**PSE&G** Public Service  
Electric and Gas  
Company

August 20, 1984

HOPE CREEK GENERATING STATION  
DOCKET NO. 50-354  
DRAFT SAFETY EVALUATION REPORT  
OPEN ITEM STATUS

Attachment 1 is a current list which provides a status of the open items identified in Section 1.7 of the Draft Safety Evaluation Report (SER). Items identified as "complete" are those for which PSE&G has provided responses and no confirmation of status has been received from the staff. We will consider these items closed unless notified otherwise. In order to permit timely resolution of items identified as "complete" which may not be resolved to the staff's satisfaction, please provide a specific description of the issue which remains to be resolved.

**FIGURE A-13-30**  
**RESPONSE SPECTRA COMPARISON,**  
**AUXILIARY BUILDING AT ELEV. 102' - 0".**  
**N-S, OBE, 2% DAMPING**

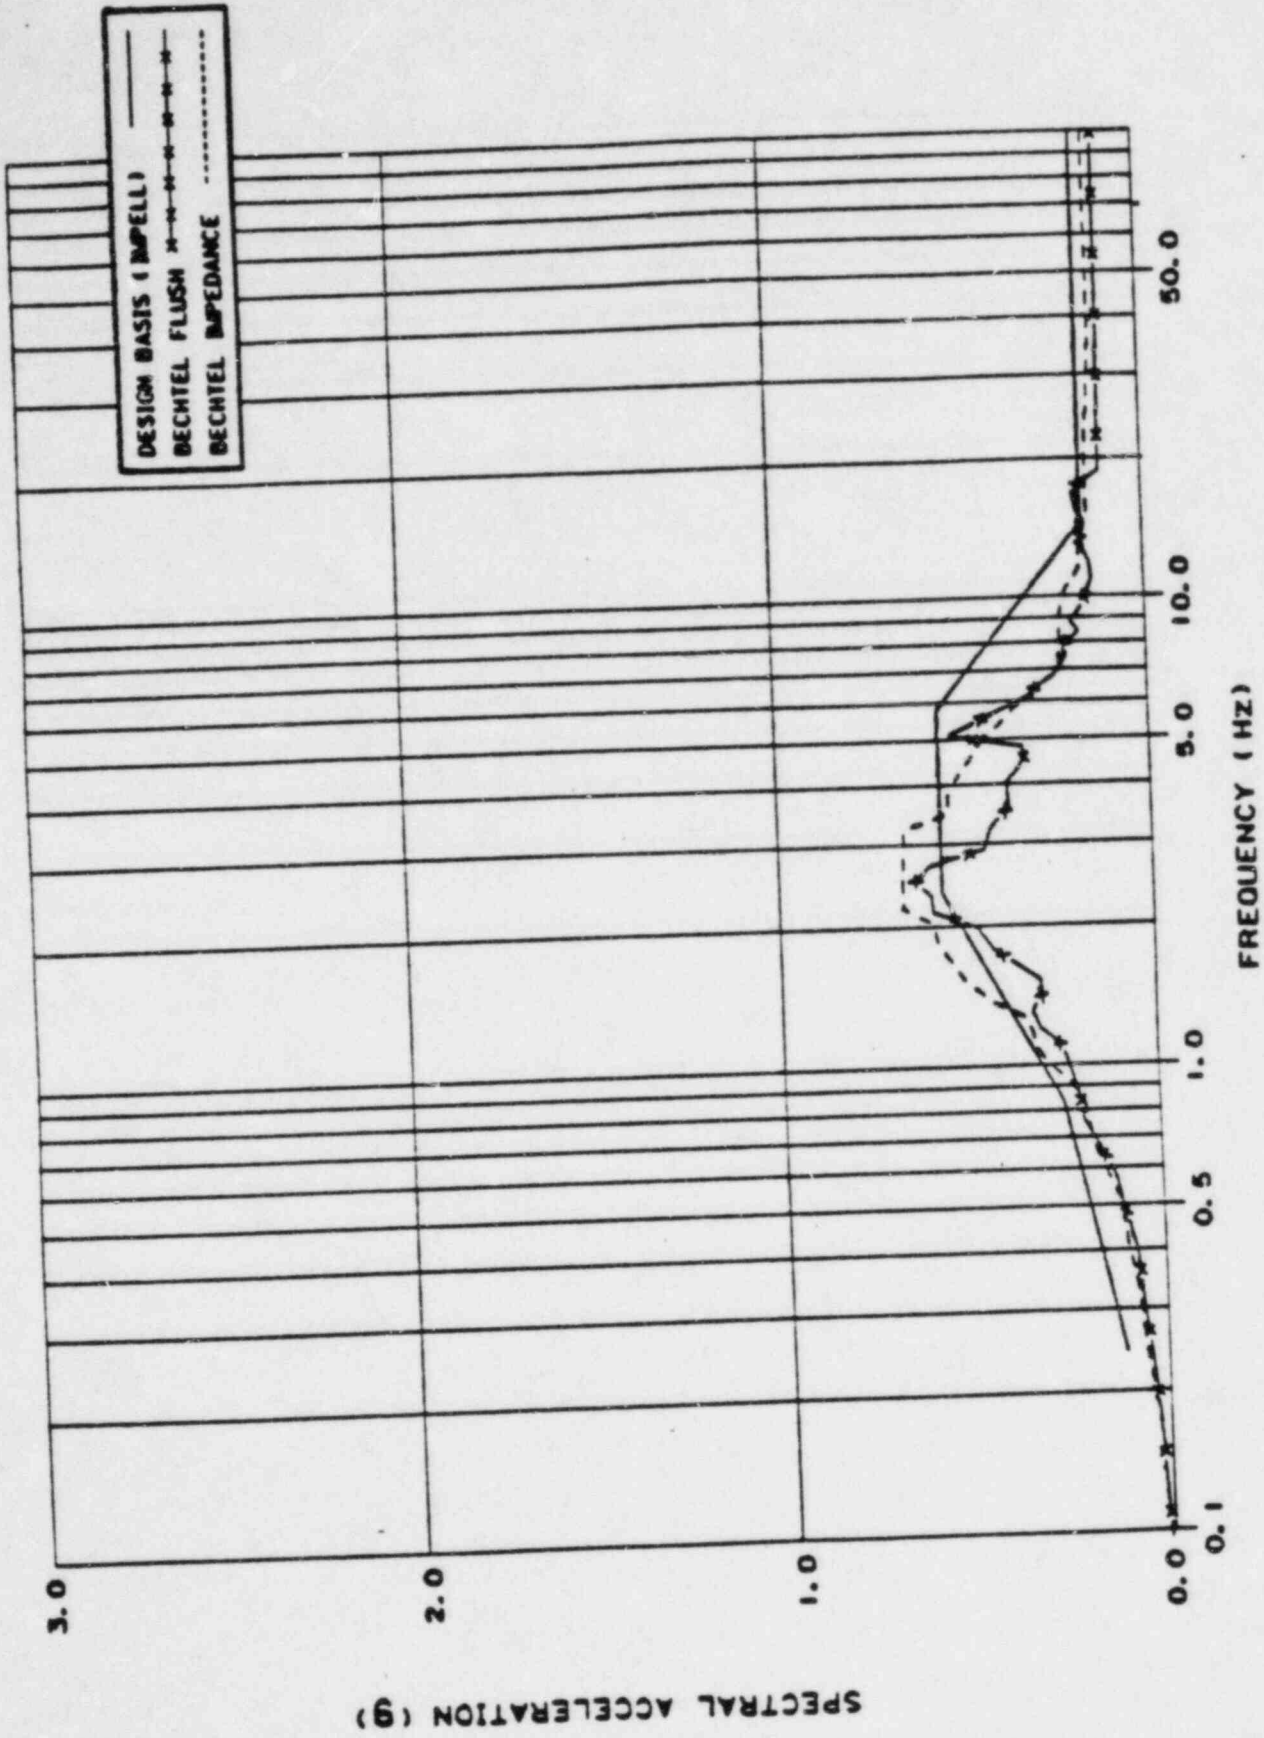
Figures A-13-2 to A-13-37 show the comparison of the response spectra (2% damping) obtained from the above three seismic soil-structure interaction analyses. Discussions of these comparisons are as follows:

Bechtel's independent soil-structure interaction analyses are performed using the computer code FLUSH. The results of independent finite element analyses are in reasonable agreement with those of the design basis analyses. As can be seen from Figures A-13-2 through A-13-37, the horizontal response spectra obtained from the independent finite element analyses are generally enveloped by those obtained from the design basis analyses except for the frequency range lower than 2 Hz. The vertical response spectra showed some exceedances at the frequency range of 18 Hz. These exceedances are listed in Table A-13-1.

The peak spectral accelerations obtained from the impedance approach analyses are generally lower than those obtained from the design basis analyses. However, these response spectra are not completely enveloped by those obtained from the design basis analysis, especially in the frequency range between 1.0 and 3.5 Hz. Also, there are some local exceedances in the higher frequency range, as shown in Figures A-13-2 through A-13-37.

FIGURE A-13-39  
FIXED BASE LUMPED MASS STICK MODEL  
OF REACTOR BUILDING

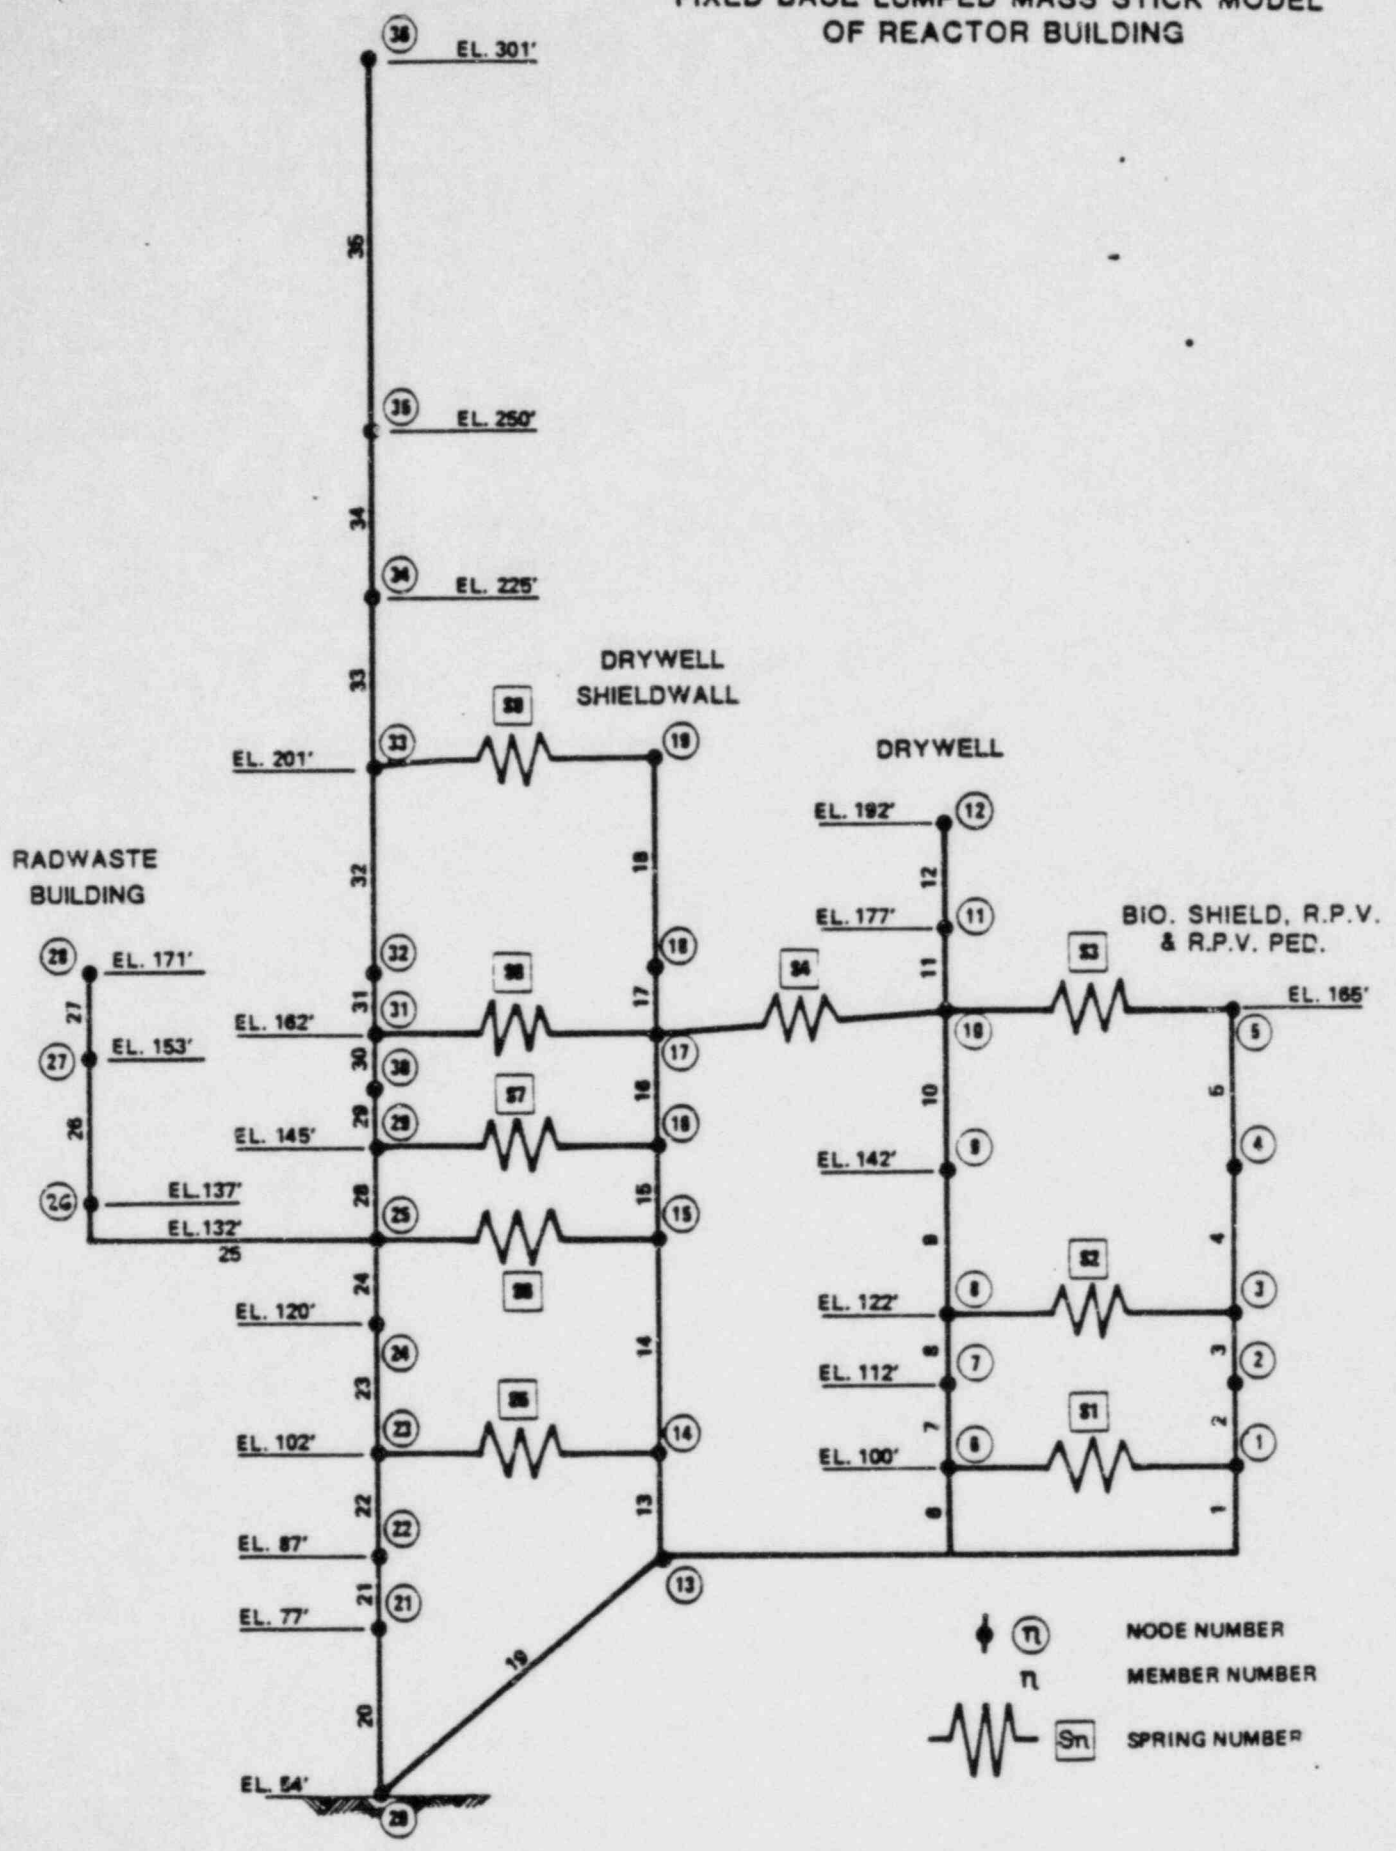
The impedance approach seismic soil-structure interaction analysis of the reactor building (Figure A-13-39) and the auxiliary building (Figure A-13-40) is performed for both the SSE and OBE cases. The foundation soil is assumed to be a uniform visco-elastic half space. The weighted average of the final iterated shear moduli of 3,522 ksf (shear wave velocity of 989 ft./sec.) and 5,235 ksf (shear wave velocity of 1,205 ft./sec.) respectively, are used in calculating the horizontal SSE and OBE impedance functions. Since the groundwater table is located at elevation 98.0 ft., a compressional wave velocity,  $V_p$ , of 4,800 ft./sec. is used for the vertical analysis. The computed OBE and SSE translational and rocking impedances for the embedded reactor building and auxiliary building foundations are given in Tables A-13-9 to A-13-12.
